**TITLE: DECLARATION OF SURPLUS PROPERTY**, requested by the Director of the Parks and Recreation Department, declaring 1.2 acres, more or less, as surplus property, generally located at the southwest corner of Superior Street and Lewis Avenue.

**P.A.S.:** Comprehensive Plan Conformity #03003  
Lewis Avenue Surplus Property

# COMPREHENSIVE PLAN CONFORMANCE NO. 03003

COMPREHENSIVE PLAN CONFORMANCE #03003  
 PROPOSED SITE PLAN  
 APRIL 11, 2003

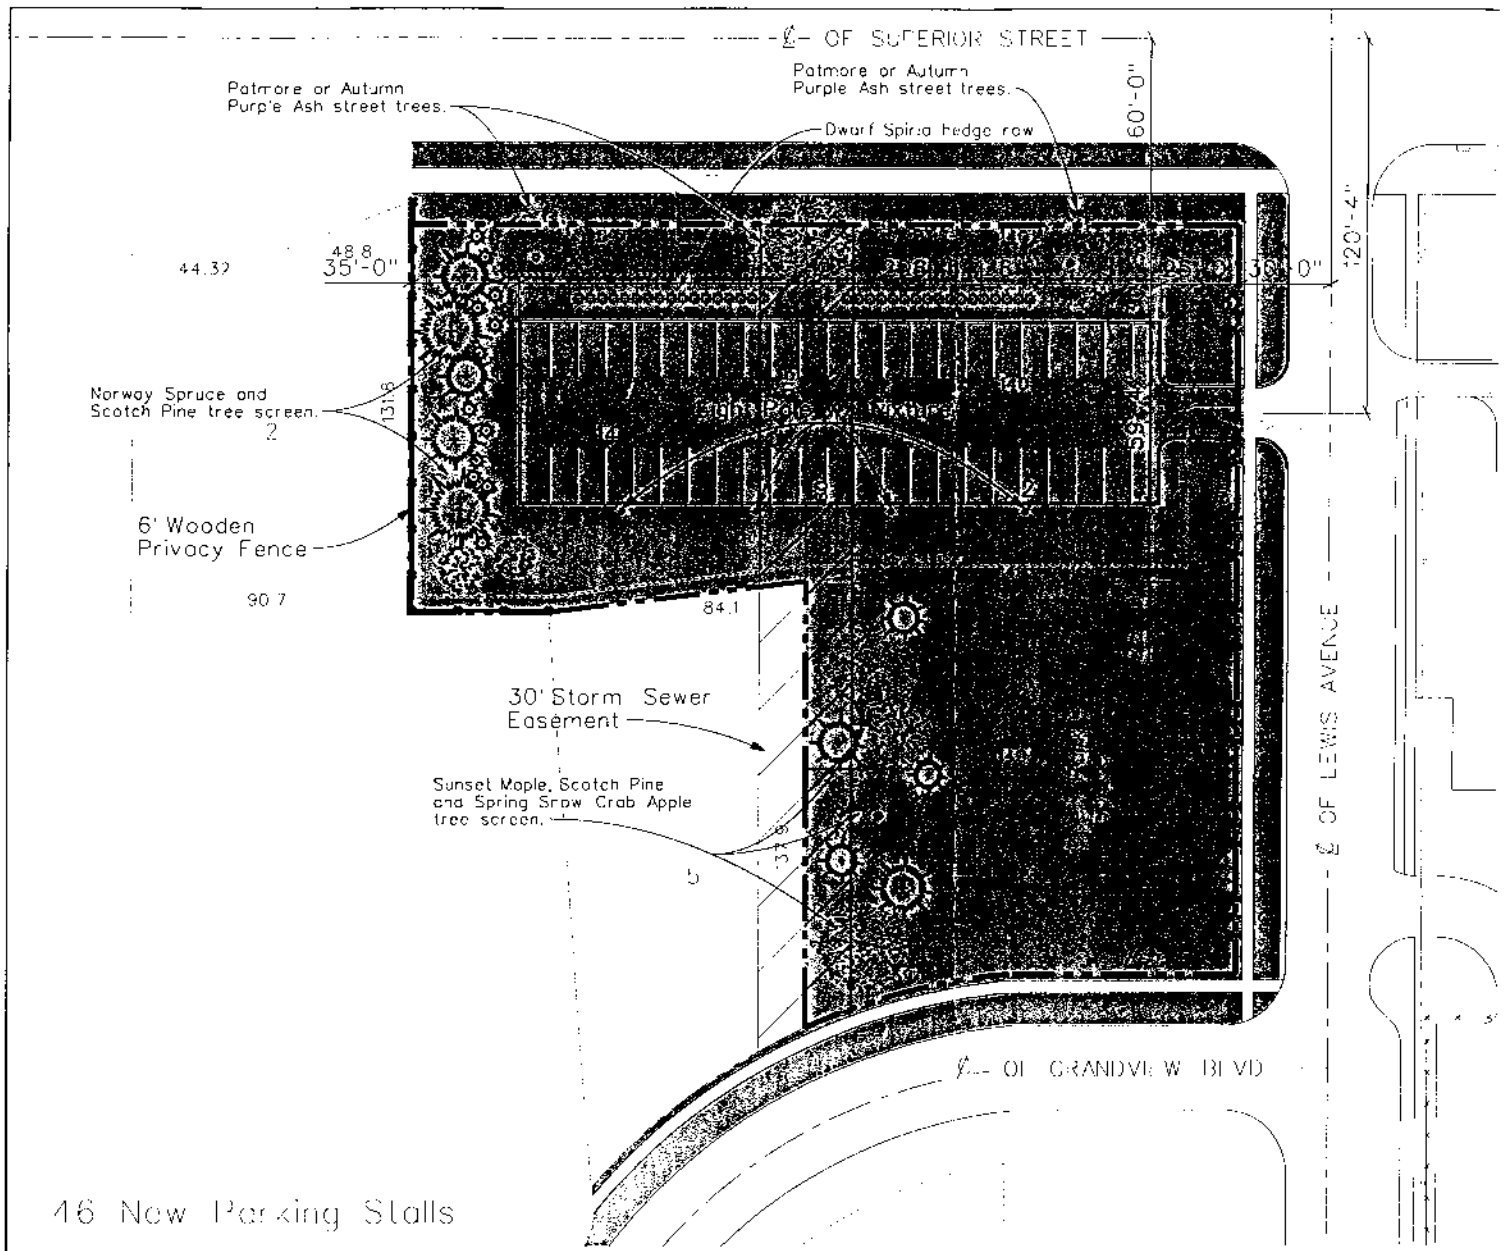
7. LPS has agreed to provide screening and landscaping for the future parking lot. The current plan shows a 6 foot high privacy fence along the western property along with some landscaping. LPS agreed to increase the design height of the landscaping along the west property line in order to provide more screening. Additional, landscaping is shown to the southwest. It is our understanding, that this property owner to the southwest did not want a privacy fence constructed.

Henrichsen also explained the revised site plan submitted by LPS in response to the letter in opposition from Mark and Laura Klute. Henrichsen showed the location of the Vorovka and Klute property at the map. The revised site plan also proposes a 6' privacy fence along the west line to the Klute property. There is also landscape screen along the west side. The westernmost parking stalls have been eliminated at the request of the Klutes to provide a 35' setback. Klute had asked that the parking lot be oriented north/south and Vorovka supports the east/west orientation. LPS has met with the property owners and adjacent neighbors. After reviewing both site plans, LPS has determined that the east/west orientation works best. The main issue is the large green space on the northwest corner, with Goodrich Middle School immediately to the east. This open space would be a place for students to go after school. With this plan, the green space will be immediately adjacent to the school for observation. Vorovka is in favor of the open space at this location.

Bills-Strand made a motion to find the proposed declaration of surplus property to be in conformance with the Comprehensive Plan, with amendment to the site plan to add the 6' privacy fence on the north side of the Vorovka lot, seconded by Steward.

4. There was no testimony in opposition.
5. On April 16, 2003, the Planning Commission agreed with the staff recommendation and voted 7-0 to find the proposed declaration of surplus property to be in conformance with the Comprehensive Plan, subject to the revised site plan dated April 11, 2003 (p.9), and a 6' privacy fence on the north side of the Vorovka property. (See Minutes p.6).
